**FIRST AMENDMENT TO AGREEMENT BETWEEN
THE CITY OF LEAGUE CITY AND EXXONMOBIL PIPELINE COMPANY, LLC.**

NASA Bypass & Landing Blvd Expansion ROX Conflict

Figure 4: Retaining wall conflict approximately 241 ft. of pipe in conflict.

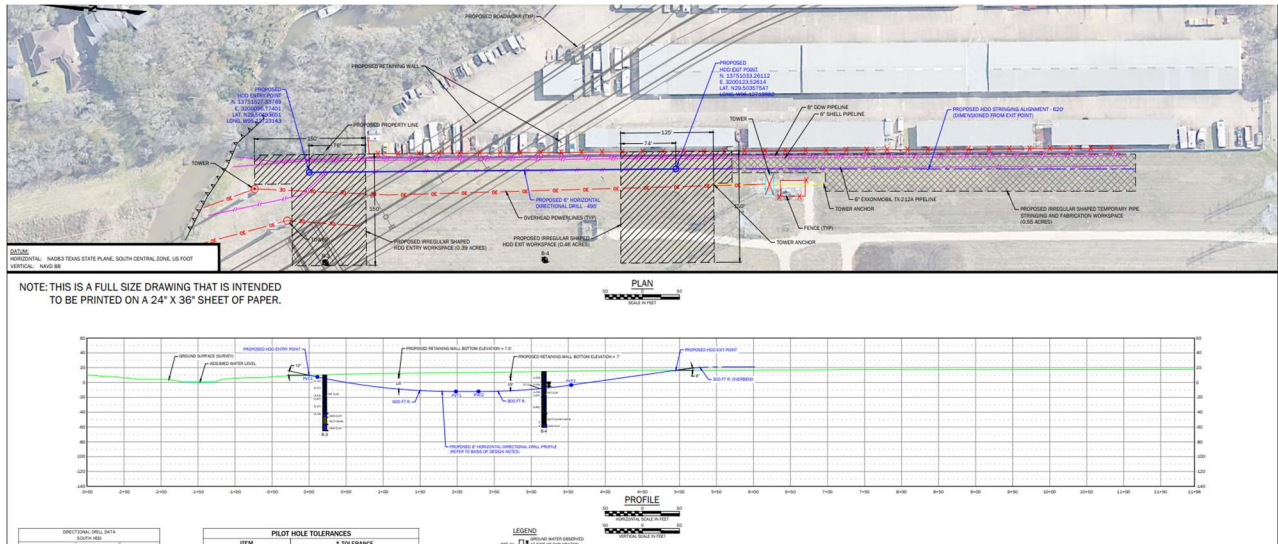
League City proposes to extend both NASA Bypass and Landing Blvd creating a conflict with pipeline TX-212a containing chemical grade propylene. Two proposed areas conflict with pipeline, the NASA Bypass drainage box and Landing Blvd retaining walls.

Figure 5: Proposed redlines to lower line below retaining walls conflict.

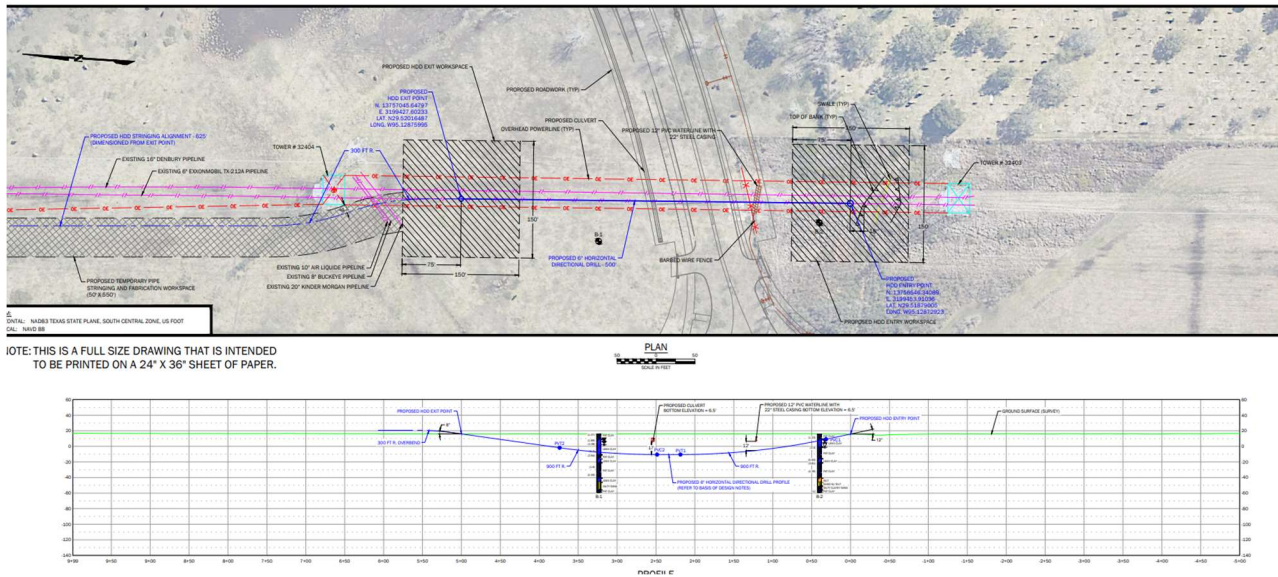
TX-212a will need to be flared from FM 518 Valve 3049 to Petrotex Valve 3036 for a total of **1,345 bbls**. Increase in flaring distance due to inaccessible valve site shown in initial scope. The line will be HDD'd in two separate locations and tied back into the existing line. New piping will be welded in, coated and recommissioned Both drills will be ~500 ft. in length achieving a DOC of ~30 ft. Existing pipe will be removed. Distance from the points of conflict are also shown in the drill drawings in Figures 5 & 6.
